## DESIGN STANDARDS/PRACTICE EXCEPTION REQUEST SUMMARY

#### Title: Gravel Road to Paved Road Upgrade

Project Location								
Highway	Control Section	At km	From km	To km	Existing AADT			
661	02		23.250	24.300	350

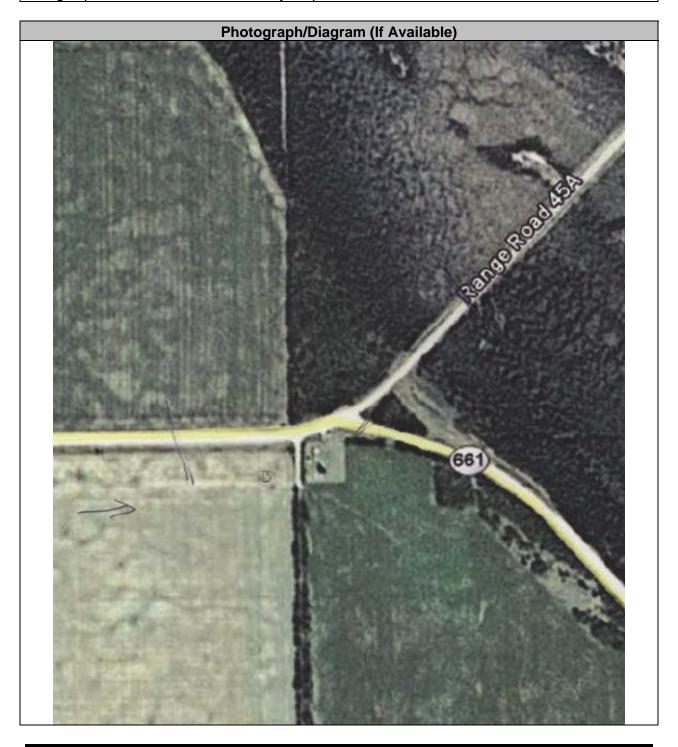
- Roadway Width: The proposed pavement width is 10m while the design designation is RAU-209-110. Normally to provide for two future overlays with 80mm ACP thickness on each overlay, the initial width needs to be 10.28m. In this case the traffic volume is at the low end of the range (350 existing AADT with 15% trucks) and therefore it is possible that the future overlay thickness may be less than the typical 80mm for each overlay. Therefore a 10m initial width is acceptable.

- Horizontal Curve Radius: The proposed radius is 340m which is suitable for a design speed
  of 90 km/hr. This curve is located at the transition from Hwy 661 to Range Road 45A. The
  highway has a posted speed of 100 km/hr and the Range Road has a posted speed of 80
  km/hr. It is proposed that the curve be posted at 80 km/hr. With the revised speed posting,
  the 340m radius is acceptable.

- The intersection has an unconventional traffic control scheme as the east leg of Hwy 661 stops for the Hwy 661/Range Road 45a traffic. The existing traffic control and alignment has been in place for over 10 years since before Alberta Transportation was the road authority. The collision record is very good with only one reported animal collision (PDO). The east leg of Hwy 661 leads to a ferry crossing of the Athabasca River. The ferry is closed from mid-November to mid-May for most years due to ice on the river. Consequently there is a good rationale to support the traffic control as it is. The proposed traffic control scheme with no change is acceptable.

The posting of Hwy 661 eastbound at 80 km/hr prior to the curve and intersection to allow for a safe operating speed on the curve.
